**A/YL-KTN/1174 – Address DSD's comments**

**Temporary Shop and Services for a Period of 5 Years,  
Lot 283 S.A RP (Part) in D.D. 109, Kam Tin, Yuen Long,  
New Territories**

## **Drainage Proposal**

FIGURE 6

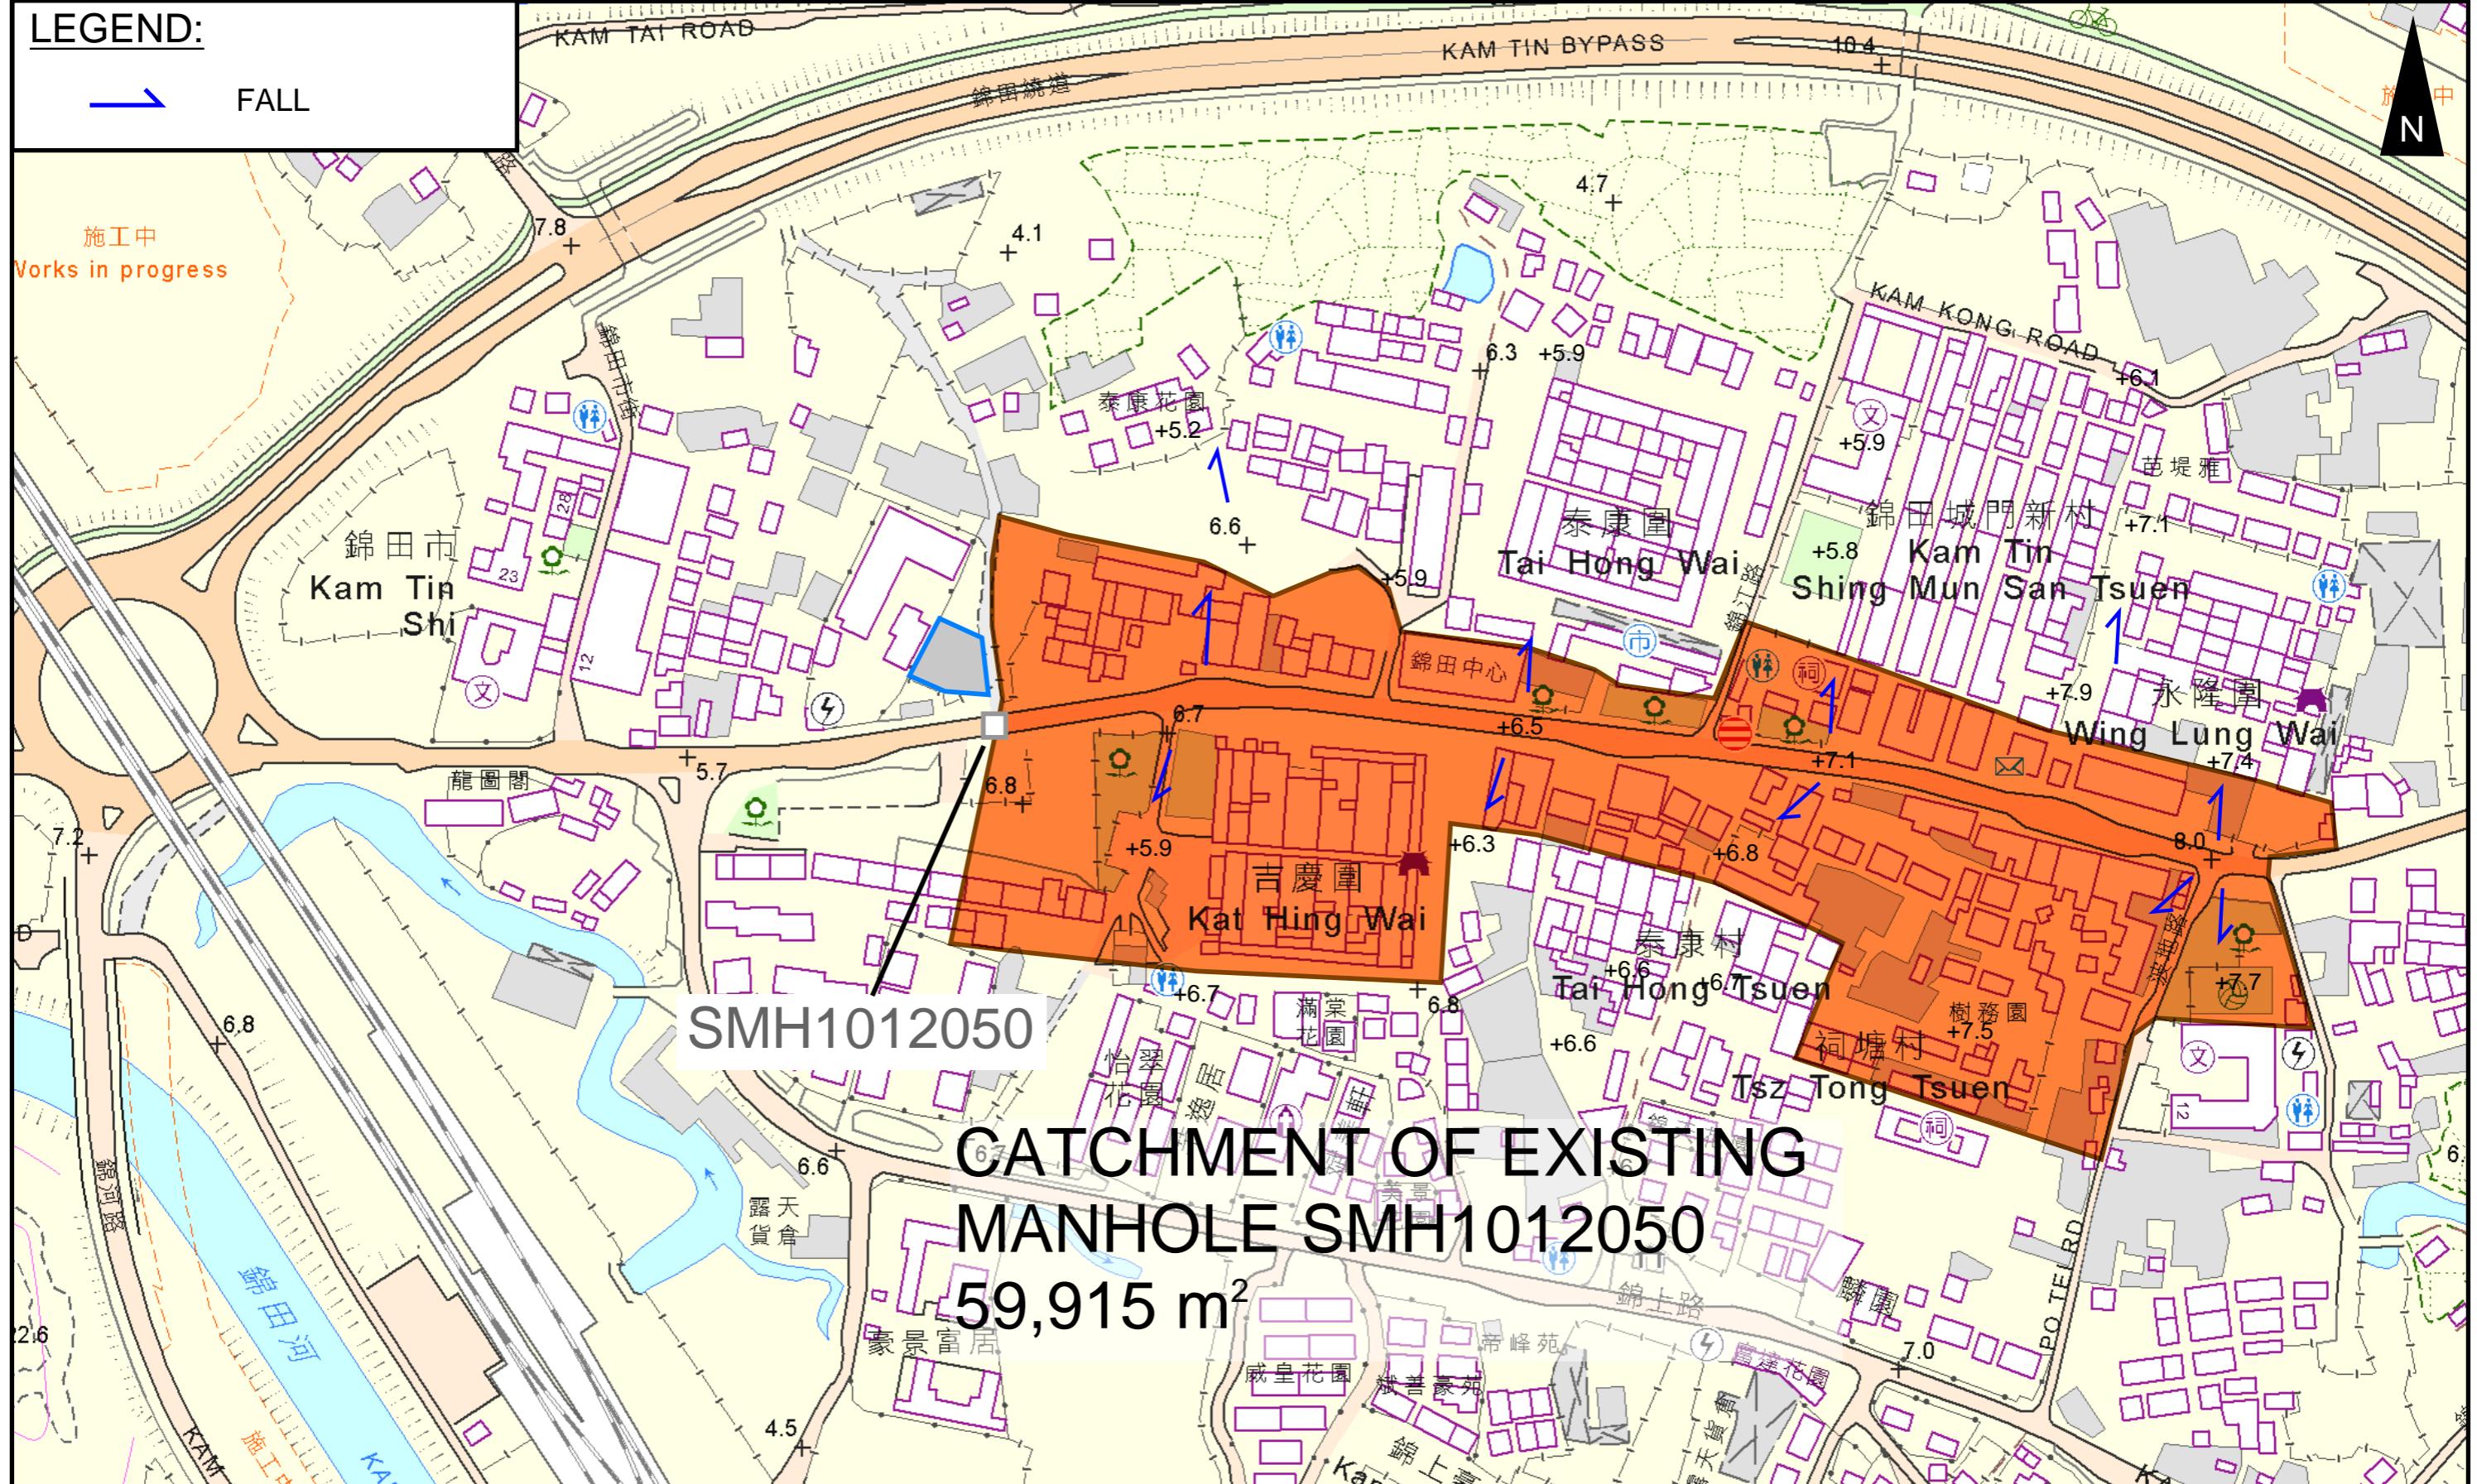
| 6  | The applicant should demonstrate the existing facilities to be discharged to have sufficient capacity to cater for any additional flow generated due to the subject application.   | <p>Noted. Existing 1650 drain and its catchment is assessed in Appendix A and catchment plan in Figure 6 for your perusal. The catchments are assumed to be fully paved for conservative purposes. It has enough capacity to cater for existing and proposed flow.</p> <p>In addition, according to checking, the flow from application site only occupy 0.9% capacity of existing 1650 drain.</p> |

TERMINAL MANHOLE  
TYPE T3\_1

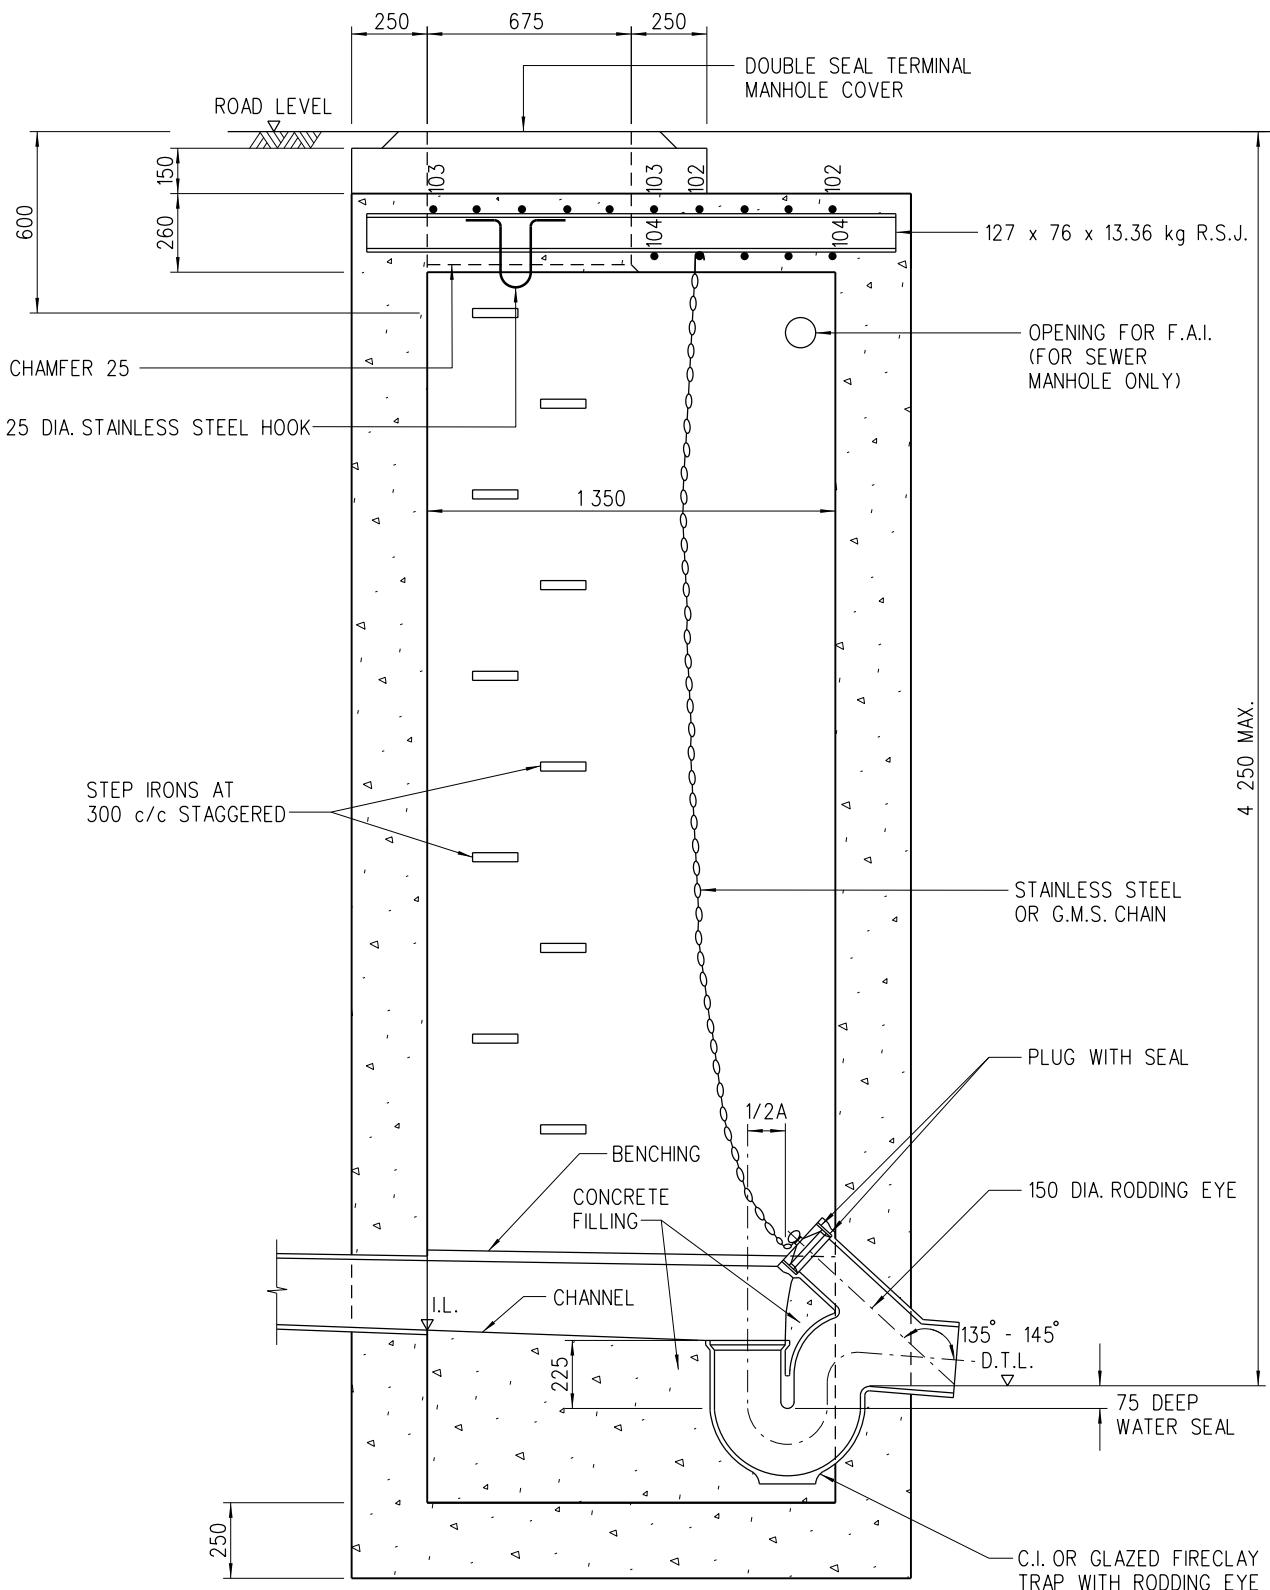
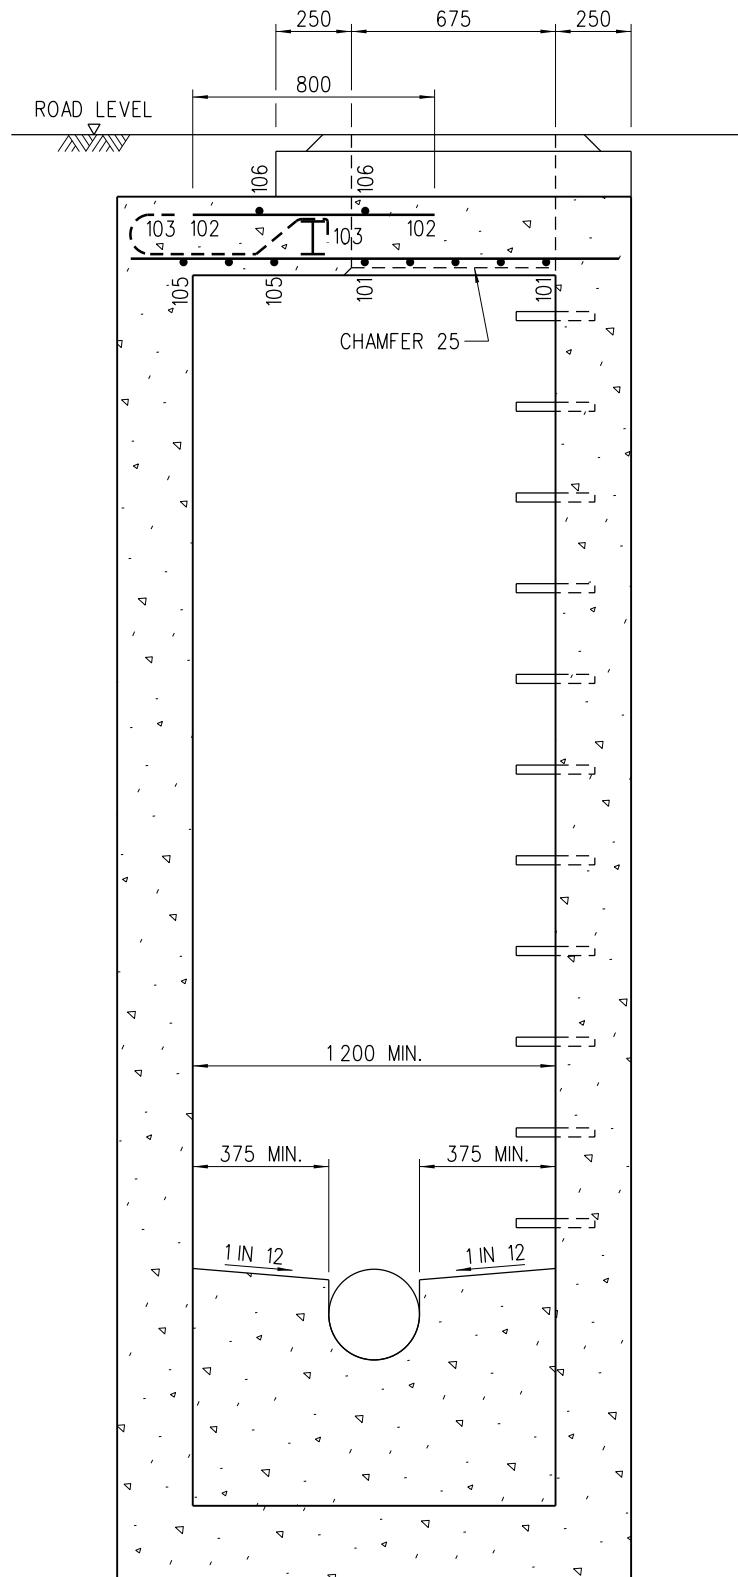
| 9  | Sand trap or provision alike should be clearly indicated on the proposed drainage plan and provided before the collected runoff is discharged to the public drainage facilities.   | Noted. Terminal Manhole Type T3_1 is proposed before discharge to public drainage facilities.  |
